**BELL BEND NUCLEAR POWER PLANT
RESPONSE TO ENVIRONMENTAL REQUESTS
FOR ADDITIONAL INFORMATION STO 2.1-1 AND
TE 2.4.7, AND SCHEDULE UPDATE FOR TE 2.4-6
BNP-2011-011 Docket No. 52-039**

Partial Response to RAI STO 2.1-1 and Response to RAI TE 2.4-7

Figure 1 – Important Terrestrial Habitats in the Vicinity of BBNPP

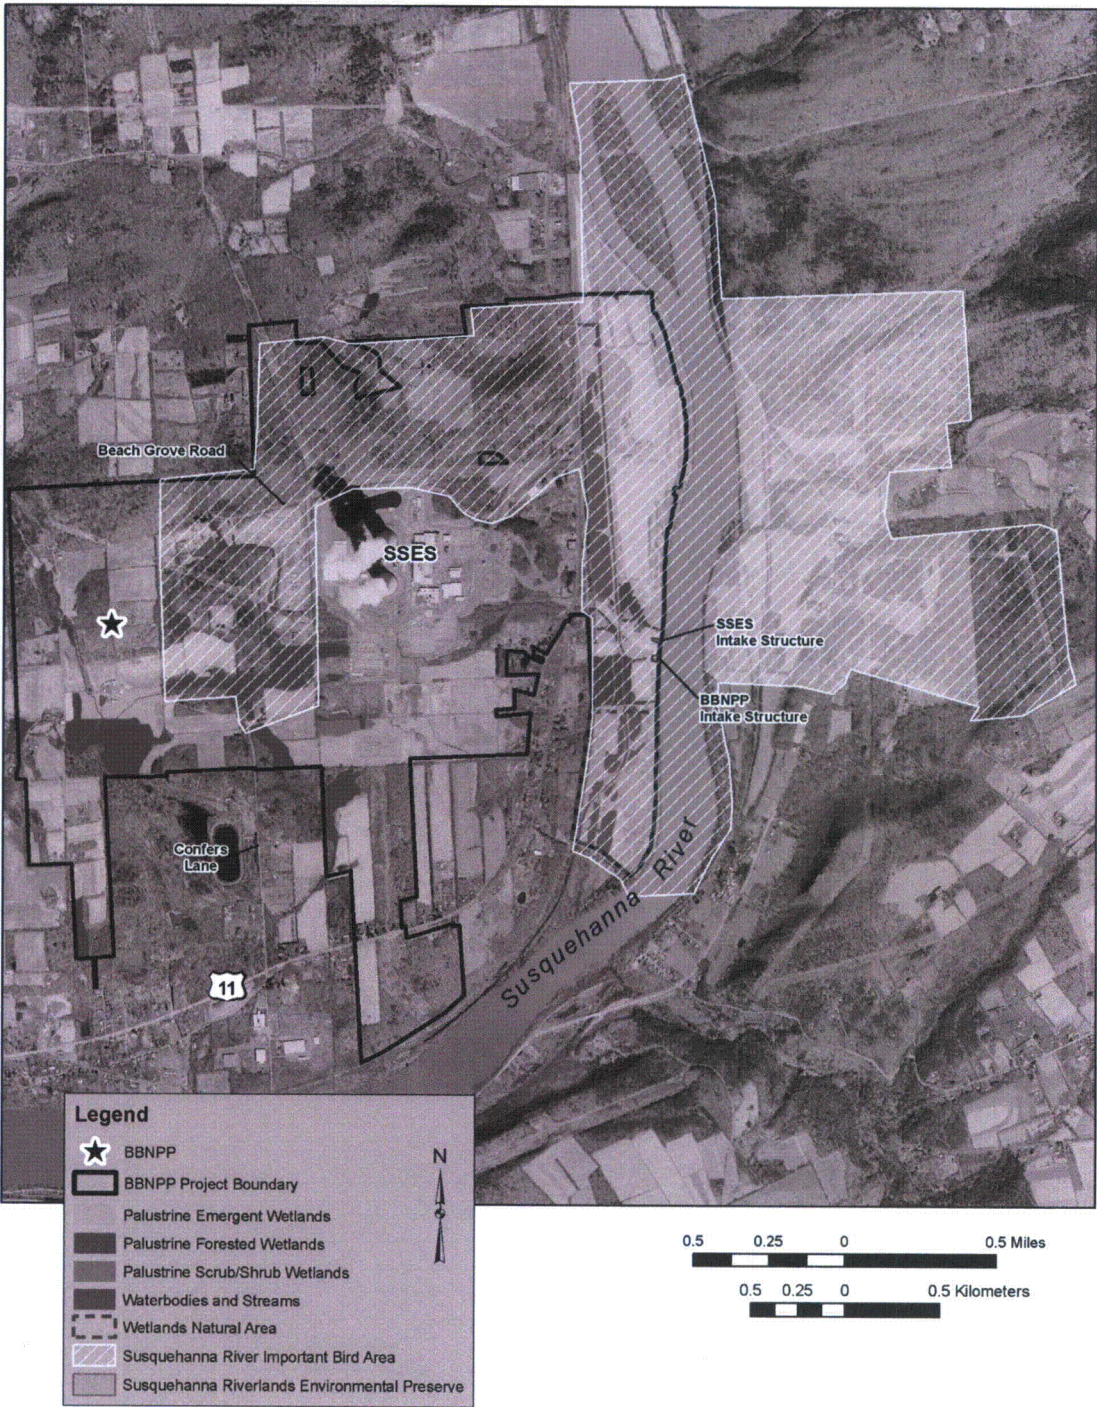
Summary: *Provide all Geographic Information System (GIS) and/or CAD data/databases used to support the ER analysis and results including existing and proposed conditions as appropriate. The data should generally include, but are not limited to:*

Full Text: PNNL has developed a GIS tool to assist in the conduct of impact assessments and to create figures where necessary. Databases used by the applicant are typically requested for addition to this GIS tool.

Response: This partial response provides a black & white version of ER Figure 2.4-7 (see Figure 1) and completes PPL's response to RAI STO 2.1-1. The enclosed CD contains this figure in TIFF format without the caption. The remainder of the response for RAI STO 2.1-1 was provided in BNP-2010-227 on October 27, 2010 (ML 103070310).

Figure 2.4-2 – Plant Community Map

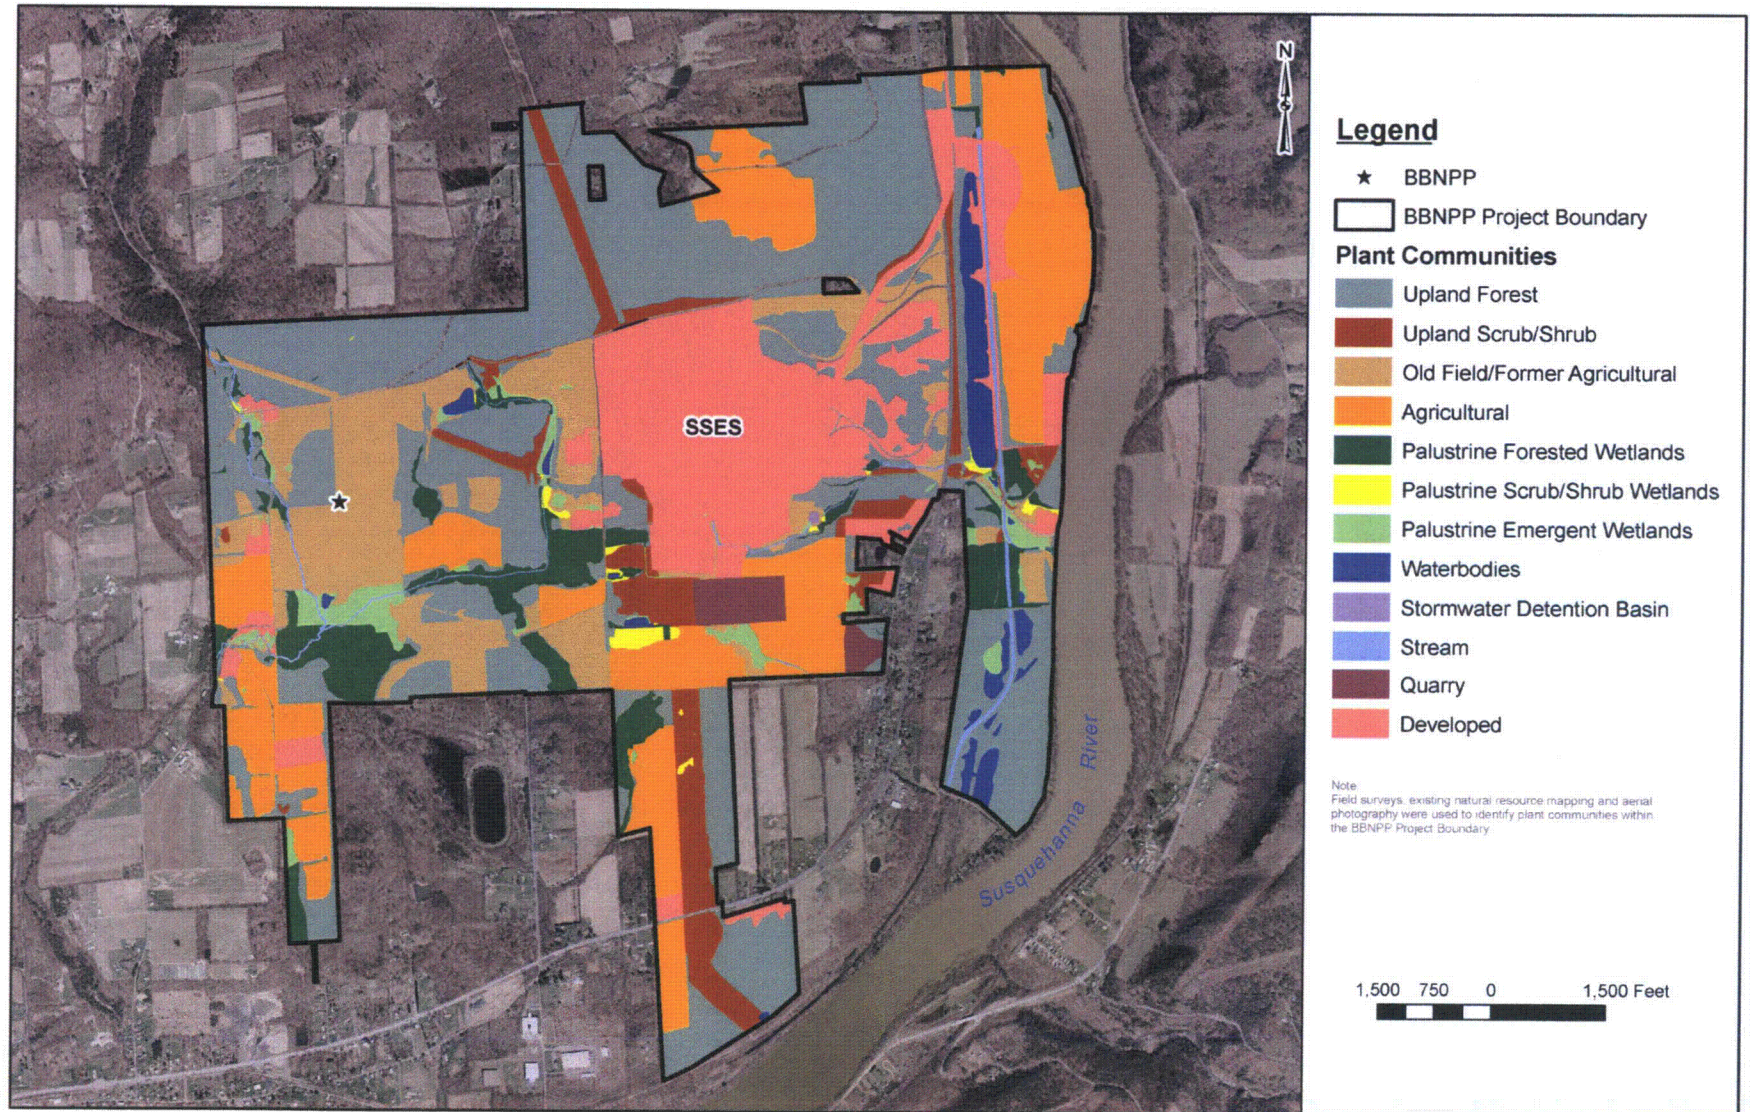
Summary: *Provide ecological information describing the area identified for the proposed Susquehanna 500kV Switchyard 2.*

Full Text: In section 1.2.5 of the ER, it is stated that “one new 500 kV transmission system switchyard (Susquehanna 500 kV Yard 2),” would be constructed on the BBNPP site. In Figure 2.1-1, BBNPP Site and Proposed New Plant Layout, the area identified for the Proposed Susquehanna 500kV Switchyard 2 falls outside of the OCA. Clarify this apparent inconsistency (ref ER sections 1.2.5, 2.2.2.2, and 2.4.1.9), describe current land use, and provide the ecological data and community types, etc., needed to describe and evaluate potential impacts to this location. Figure 2.2-1, Land Use on the BBNPP Site, shows this area as forested.

Response: As part of the BBNPP footprint change, the location of the proposed 500 kV transmission system switchyard (Susquehanna 500 kV Yard #2) is now defined to be within the BBNPP Project boundary as will be indicated in the next revision to ER Figure 2.1-1 (reference BNP-2010-227). The ecological features of the proposed switchyard footprint area were surveyed during field studies performed in May and June 2010. The vegetative cover consists largely of mature upland deciduous forest. An existing transmission line corridor, which runs roughly north to south through the footprint, is maintained in upland old field and upland scrub/shrub communities. All vegetation communities in the vicinity of the proposed switchyard footprint are commonly found throughout eastern Pennsylvania. The footprint is well-drained and no wetlands were detected during field surveys of this area. In addition, no rare vegetation community types or species of rare plants were detected during these field surveys. Terrestrial faunal composition was similar to that previously observed in similar habitat types on other sections of the BBNPP site during the field studies performed between July 2007 and September 2008. Current land use for this area and the entire BBNPP site will be shown in the next revision of ER Figure 2.2-1 (reference BNP-2010-294). The information needed to evaluate potential impacts to land use at this location will be provided in the next revision of ER Section 2.2.1 (reference BNP-2010-294). ER Section 2.4.1 discusses terrestrial ecology within the BBNPP Site but generally does not address terrestrial ecology at specific locations such as the proposed location of Susquehanna 500 kV Yard #2. ER Figures 2.4-2 and 2.4-7 will be updated in a future revision of the COLA to show plant communities and important terrestrial habitats on and in the vicinity of the BBNPP Site. No changes are required for ER Section 2.4.2 (Aquatic Ecology).

BBNPP COLA ER Figures 2.4-2 and 2.4-7 will be revised as follows in a future revision of the COLA.
